DATE: 11.27.2013
TO: ProTrak
FROM: Bill McDow
 Transportation Planning

■ TIBURON PARC APARTMENTS PHASE 2

⌘ Initial Review Notes ⌘

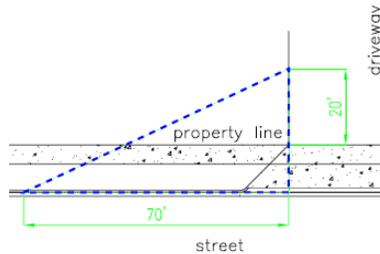
Portions of the Right Turn lane at Moynet Way and Independence Blvd and the sidewalk proposed for Phase II appear to be located on the applicant’s property, and will require a Public Access and Maintenance Easement. It is the Applicant’s responsibility to coordinate directly with NCDOT to determine if any driveway permits/ revisions/ review processes are required. Please note additional comments may be forthcoming once coordination occurs. If the proposed dedication of ROW and Access and Maintenance Easement was completed in Phase I, please provide an update on these items.
